October 22, 1987

TO: Technical File
FROM: Rick P. Summers, Reclamation Hydrologist *RPS*
RE: Response to Permit Stipulations (received 9-24-87), Summit Coal Company, Boyer Mine, ACT/043/008, Summit County, Utah

Page 7
Memo to File
ACT/043/008
October 22, 1987

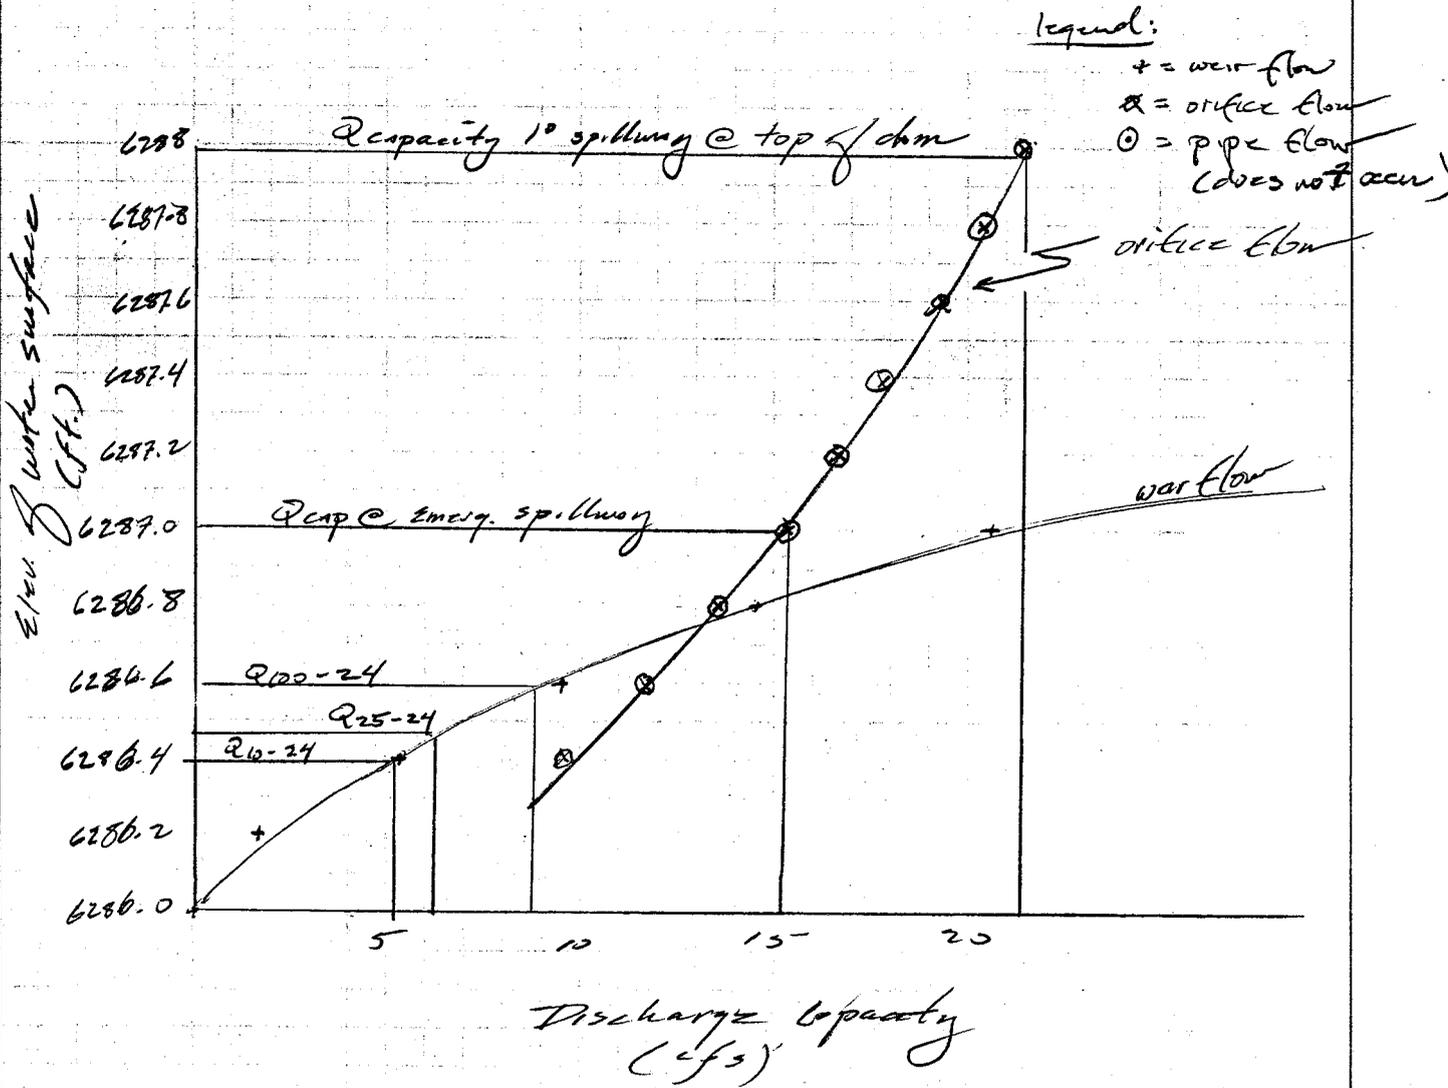
Comment:

The applicant has not committed to renovation of the diversion prior to site abandonment (i.e. following sedimentation pond removal, the applicant must insure the diversion constructed during phase 1 of reclamation is still functional as per approved design). A single paragraph describing the commitment to renovate the diversion to approved design specifications and repair of any diversion degradation which occurred prior to meeting the requirements of UMC 817.46 (u) will be sufficient for this stipulation.

*The applicant has committed to the above items on page 7-4a(1) of section 7.4.2.1. This stipulation has been addressed.
